Subject: Duke Energy Corporation  
McGuire Nuclear Station, Units 1 and 2  
Docket Numbers 50-369 and 50-370  
Catawba Nuclear Station, Units 1 and 2  
Docket Numbers 50-413, 50-414  
Proposed Technical Specifications and Bases  
Amendment  
2.0, Safety Limits; 3.3, Instrumentation; 3.4,  
Reactor Coolant System; 5.6, Reporting  
Requirements

Duke License Amendment Request of March 24, 2003

ATTACHMENT 1A

MARKED COPY

Figure 2.1.1-1

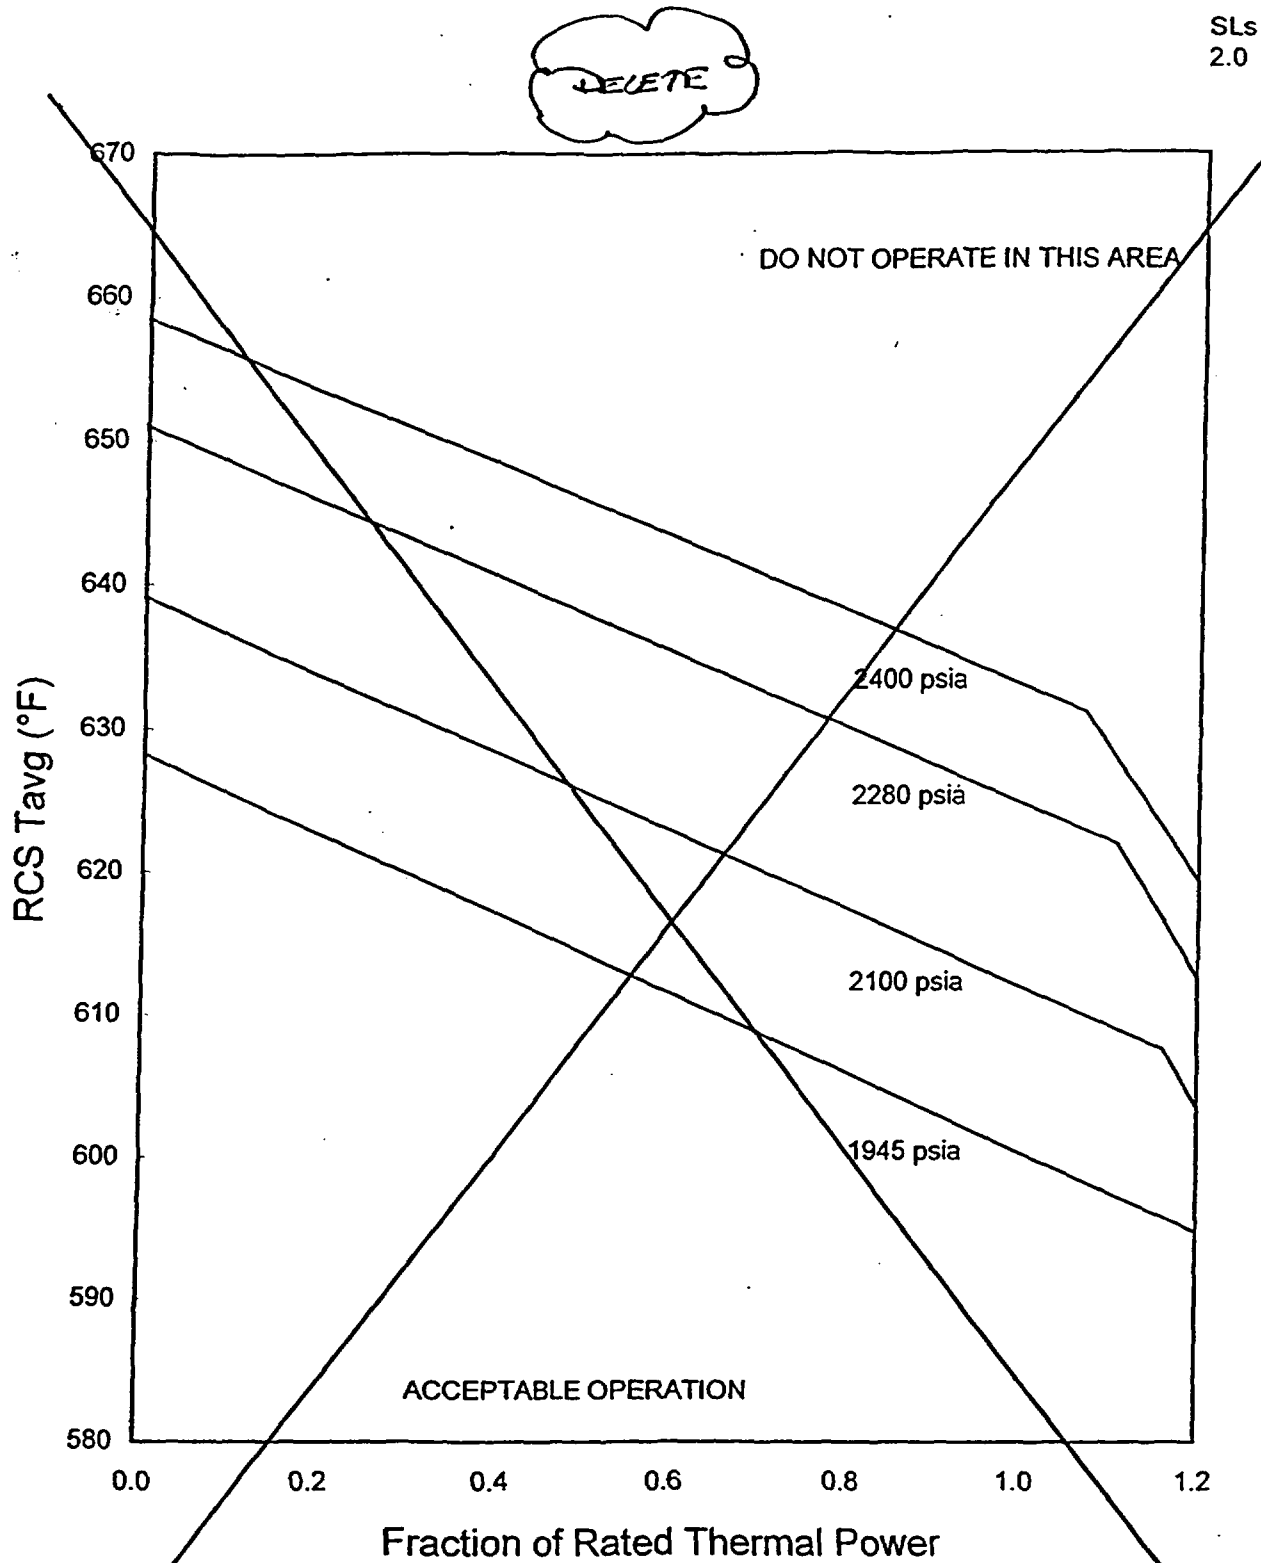
The proposed amendment changes TS 2.2.1, "Reactor Core Safety limits," and associated Bases, by relocating the reactor core safety limit figure to the COLRs and replacing it with specific fuel Departure from Nucleate Boiling Ratio (DNBR) and peak fuel centerline temperature safety limit requirements. The amendment proposes to change TS Table 3.3.1-1, "Reactor Trip System Instrumentation," by relocating Overtemperature  $\Delta T$  and Overpower  $\Delta T$  nominal RCS operating pressure, nominal  $T_{avg}$ , and constant (K) values to the respective station COLR. The amendment also revises TS 3.4.1, "RCS Pressure, Temperature, and Flow Departure from Nucleate Boiling (DNB) Limits," and associated Bases, by relocating the pressurizer pressure, RCS average temperature, and RCS total flow rate values to the respective station COLR. The minimum RCS total flow rates are retained in TS Table 3.4.1-1. TS 5.6.5, "Core Operating Limits Report (COLR)," would be modified to reflect the above relocations to the COLR.

In MODES 1 and 2, the combination of THERMAL POWER, Reactor Coolant System (RCS) highest loop average temperature, and pressurizer pressure shall not exceed the SLs specified in Figure 2.1.1 for four loop operation.

INSERT 1

- 2.1.1.1 The departure from nucleate boiling ratio (DNBR) shall be maintained  $\geq 1.14$  for the WRB-2M CHF correlation.
- 2.1.1.2 The peak fuel centerline temperature shall be maintained  $< 5080$  degrees F, decreasing 58 degrees F for every 10,000 MWd/mtU of fuel burnup.

Figure B 2.1.1-1

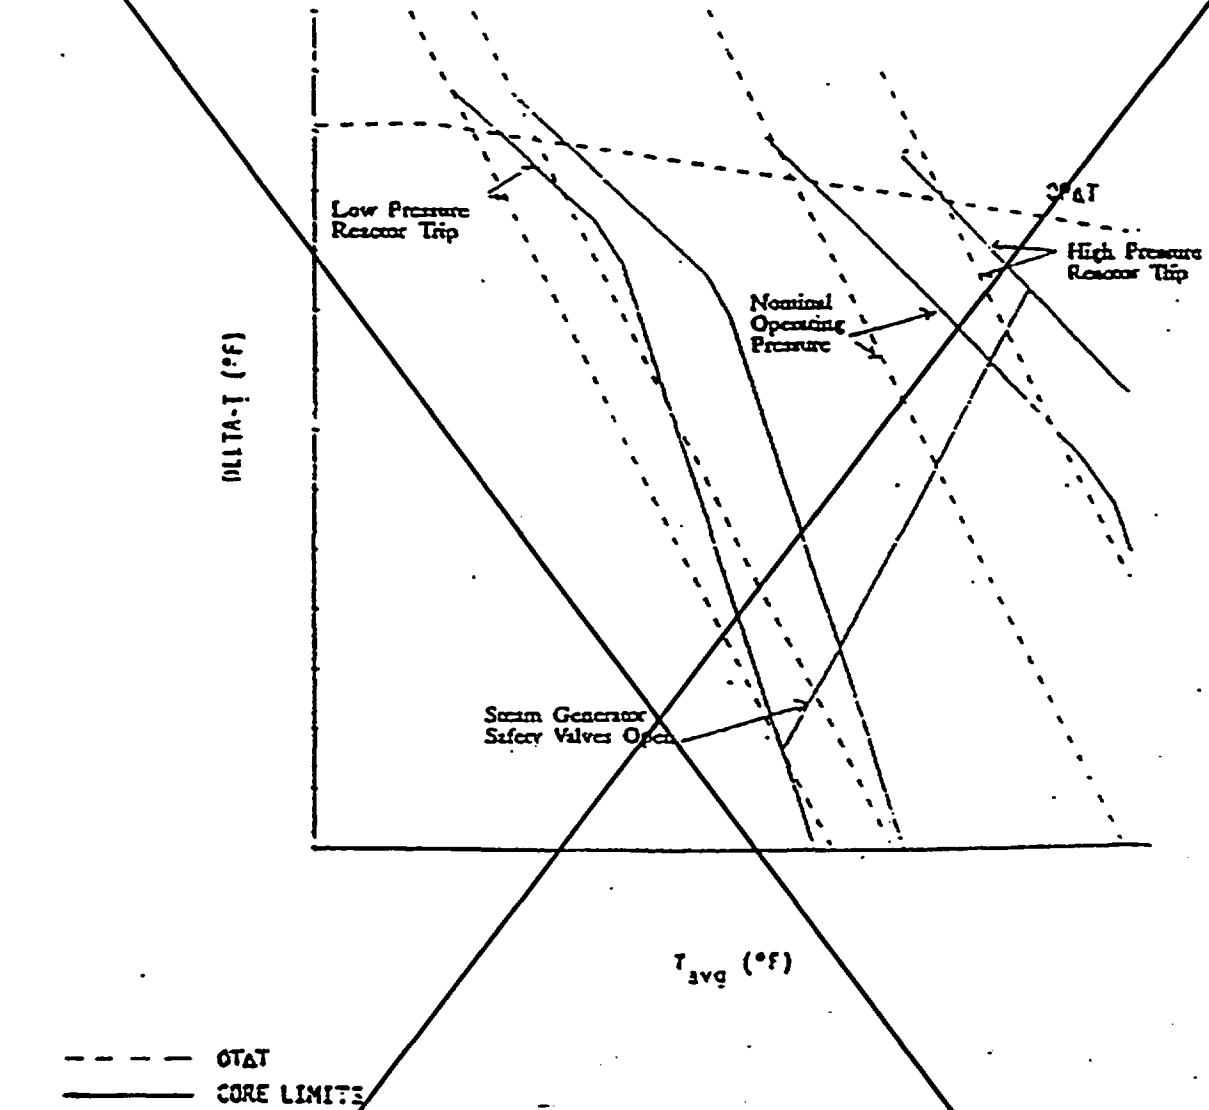
The curves provided in Figure B 2.1.1-1 show the loci of points of ~~ATX~~ RCS Pressure, and average temperature for which the minimum DNBR is not less than the safety analyses limit, that fuel centerline temperature remains below melting, that the average enthalpy in the hot leg is less than or equal to the enthalpy of saturated liquid, and that the exit quality is within the limits defined by the DNBR correlation.

The curves in Figure 2.1.1-1 are based on a reference nuclear enthalpy rise hot channel factor ( $F_{\Delta H}$ ), a reference axial power shape ( $F_z, x/L$ ), the approved CHF correlation and the Technical Specification minimum flow rate. Therefore, these curves provide limits for which the analyses analyzed at the above reference values will be bounded. The curves in Figure B 2.1.1-1 illustrate the various RPS functions that are designed to prevent the unit from reaching the limit.

DELETE

Figure 2.1.1-1  
Reactor Core Safety Limits  
Four Loops in Operation

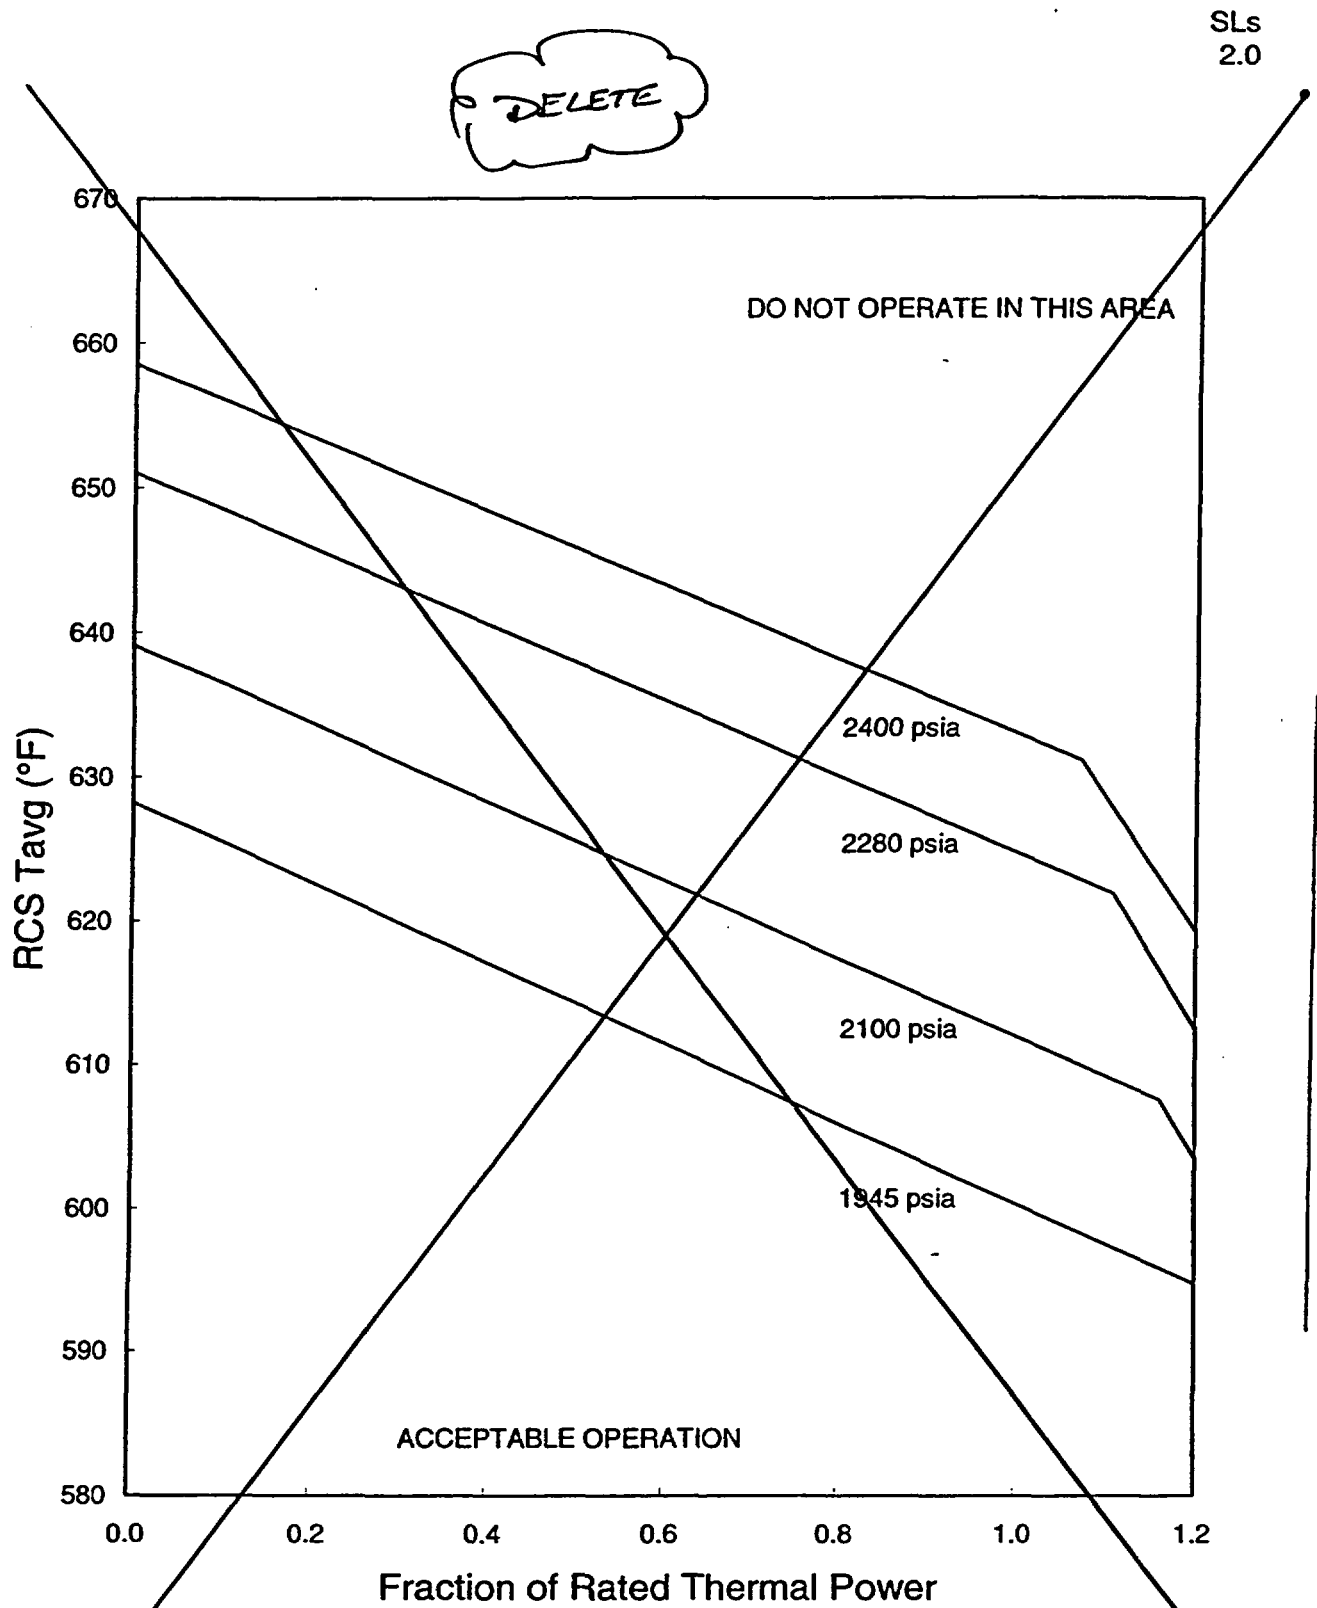
In MODES 1 and 2, the combination of THERMAL POWER, Reactor Coolant System (RCS) highest loop average temperature, and pressurizer pressure shall not exceed the SLs specified in Figure 2.1.1-1 for four loop operation.

The proposed amendment also relocates TS Figure 2.1.1-1, "Reactor Core Safety Limits," to the COLRs, replacing it with more specific requirements regarding the safety limits (i.e. fuel DNB design basis and the fuel centerline melt design basis) conforming with WCAP-14483-A. As discussed in the Safety Evaluation Reports to WCAP-14483-A, it is necessary to relocate TS Figure 2.1.1-1 to the COLR since cycle-dependent changes to parameters upon which TS Figure 2.1.1-1 is based would require a license amendment request to revise the figure.

Figure B 2.1.1-1

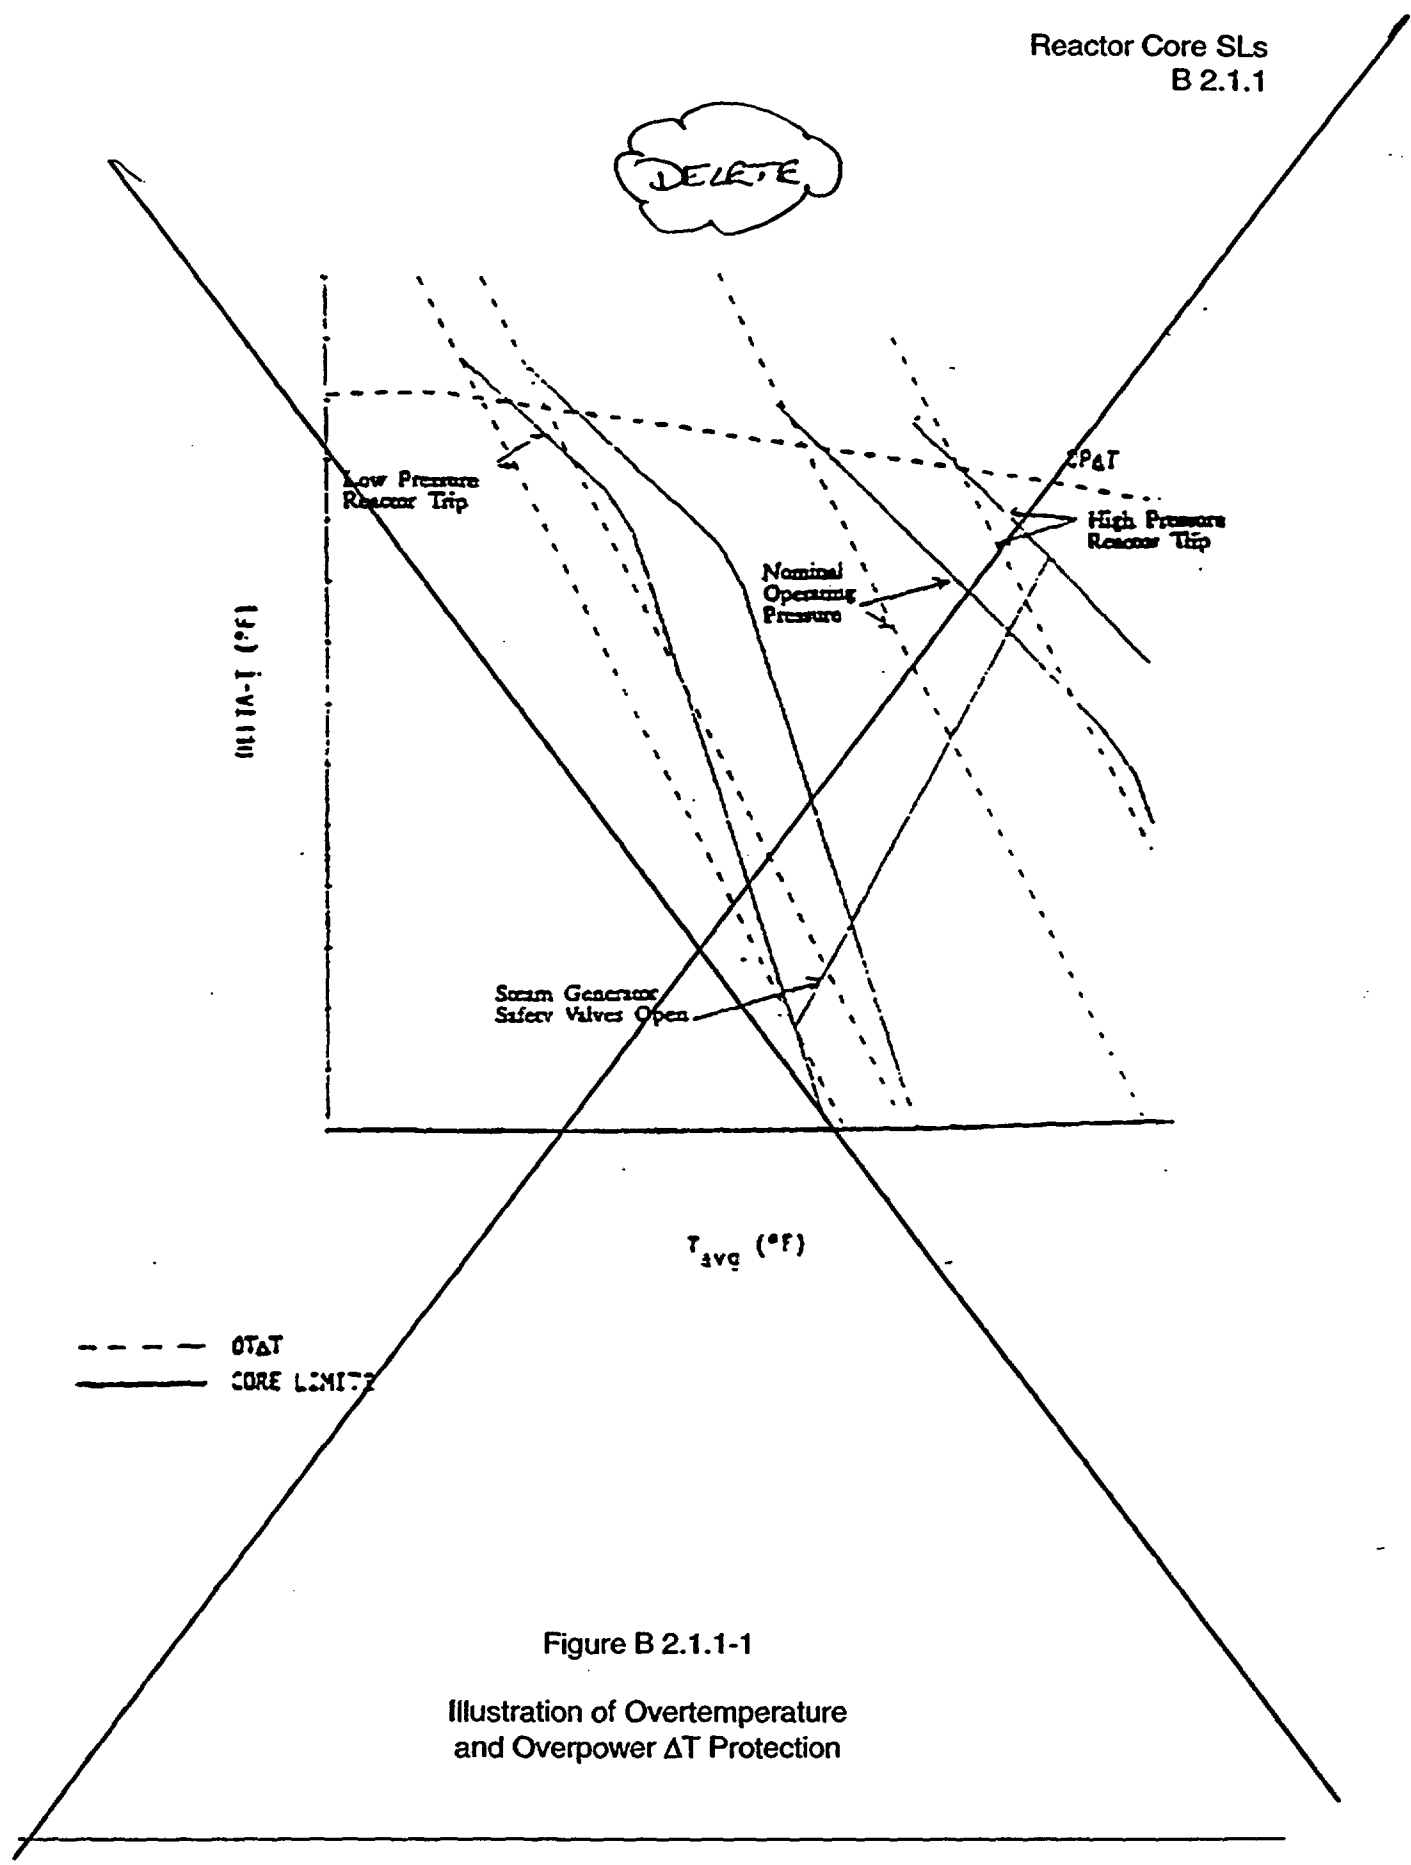
The curves provided in Figure B 2.1.1-1 show the loci of points of ~~CHF~~, RCS Pressure, and average temperature for which the minimum DNBR is not less than the safety analyses limit, that fuel centerline temperature remains below melting, that the average enthalpy in the hot leg is less than or equal to the enthalpy of saturated liquid, and that the exit quality is within the limits defined by the DNBR correlation.

The curves in Figure 2.1.1-1 are based on a reference nuclear enthalpy rise hot channel factor ( $F_{CH}$ ), a reference axial power shape ( $F_z$ ,  $x/L$ ), the approved CHF correlation and the Technical Specification minimum flow rate. Therefore, these curves provide limits for which the analyses analyzed at the above reference values will be bounded. The curves in Figure B 2.1.1-1 illustrate the various RPS functions that are designed to prevent the unit from reaching the limit.

DELETE
